P802.1Qdy - RSTP/MSTP YANG – Reusability across SDOs (version 07)
Murugan Balraj (Nokia)
murugan.balraj@nokia.com

This presentation

2 48.6.27 The ieee802-dot1q-mstp YANG module

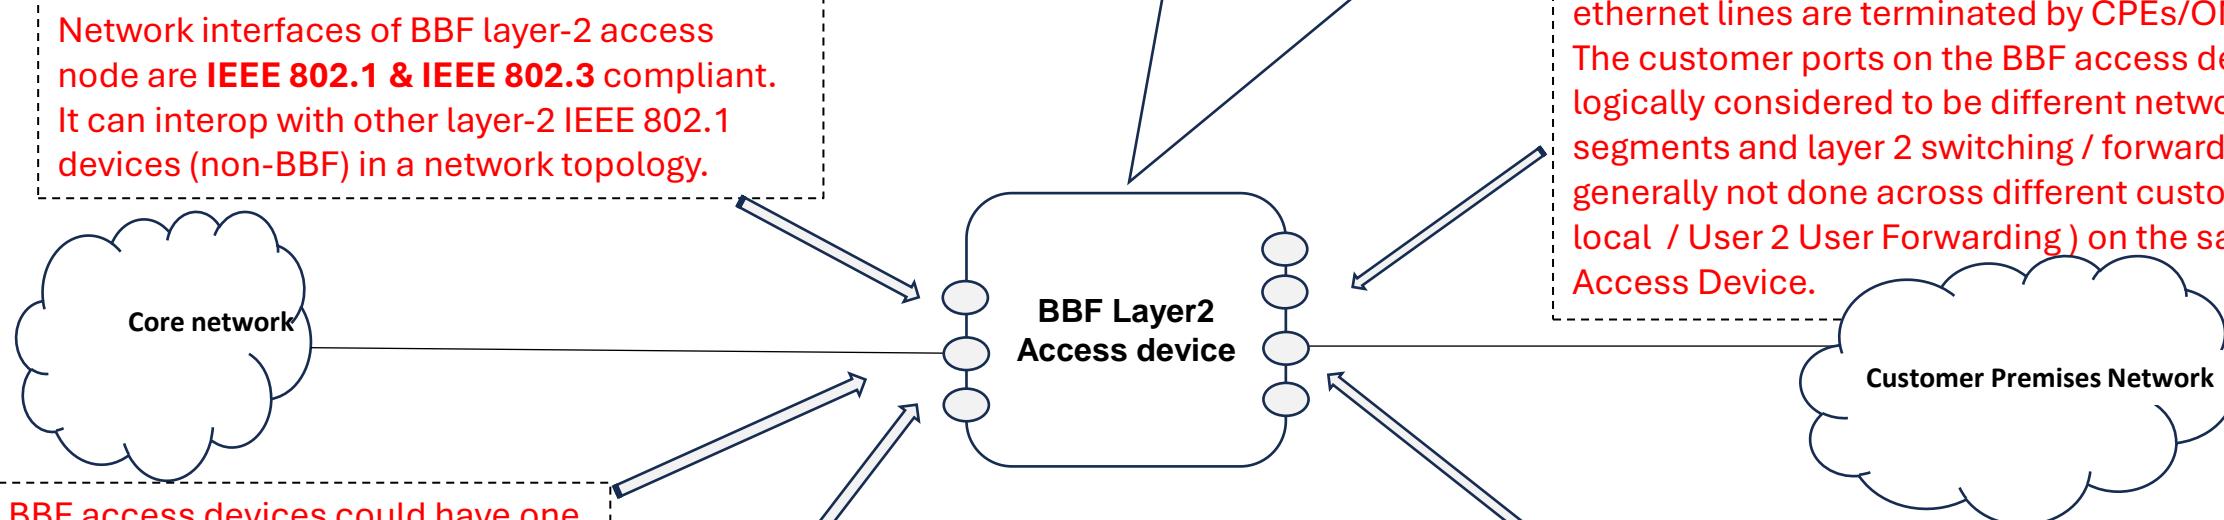
The “augments” clause present in the YANG module cannot be overridden and this makes it impossible for other SDOs to use this YANG module since they may not have the notion of Bridge / Component

Ref : [802-1Qdy-d2-0.pdf](#),
Page 19

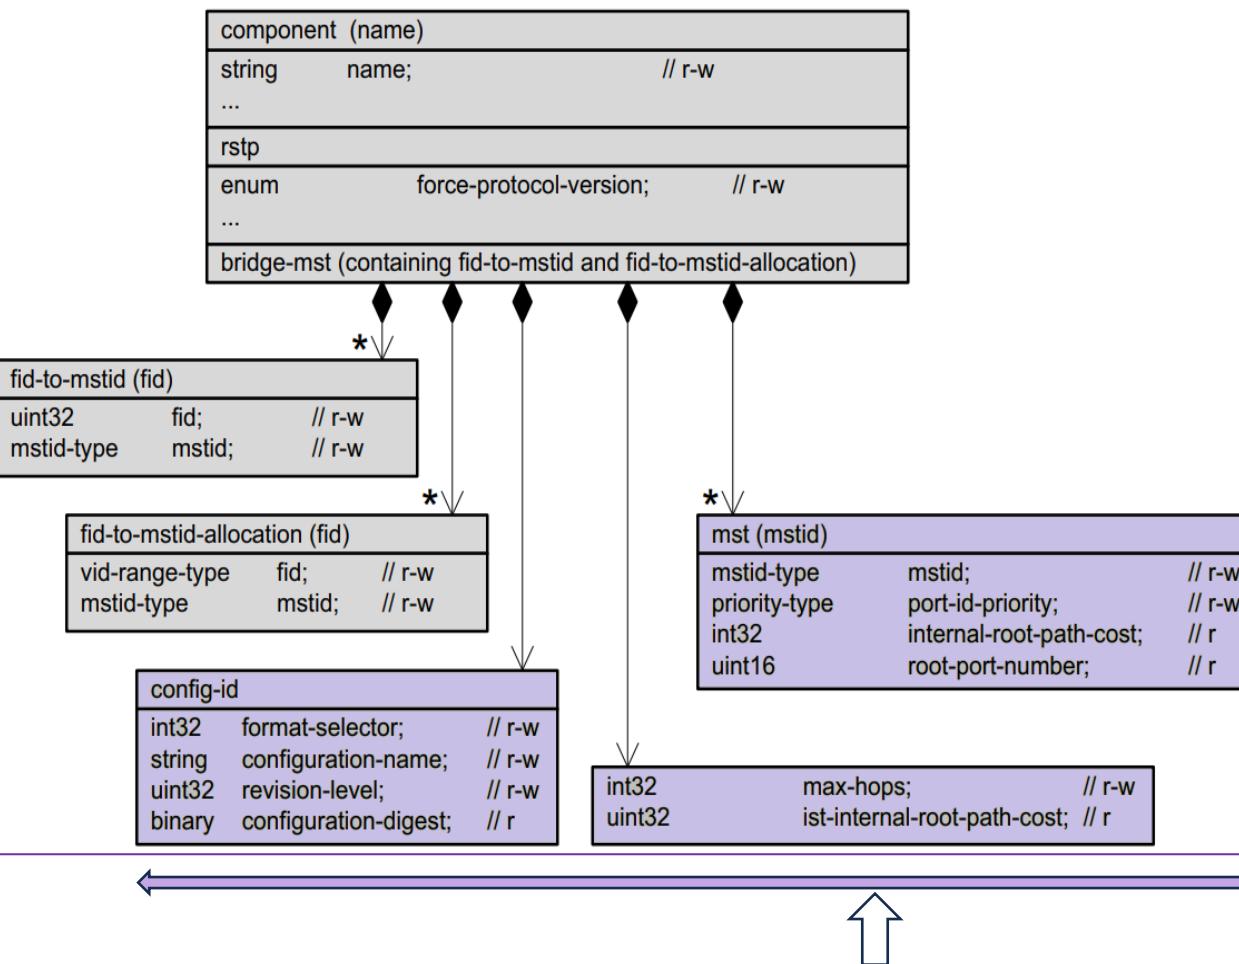
These RSTP protocol specific configuration and state data directly augment "/bridges/bridge/component".

A non-IEEE 802.1 device cannot import this YANG module due to the direct augmentation.

These RSTP protocol specific interface configuration and state data directly augment "/interface/interface/bridge-port".

A non-IEEE 802.1 device cannot import this YANG module due to the direct augmentation.

Ref : [802-1Qdy-d2-0.pdf](#),
Page 20

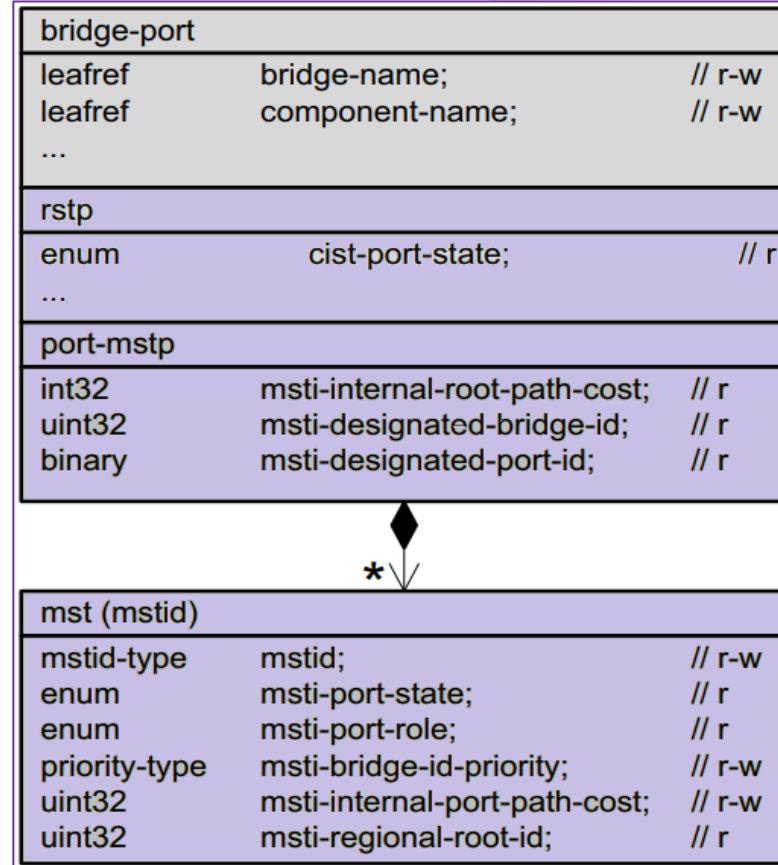
These MSTP protocol specific configuration and state data directly augment "/bridges/bridge/component".
A non-IEEE 802.1 device cannot import this YANG module due to the direct augmentation.

These MSTP protocol specific interface configuration and state data directly augment "/interface/interface/bridge-port".
A non-IEEE 802.1 device cannot import this YANG module due to the direct augmentation.
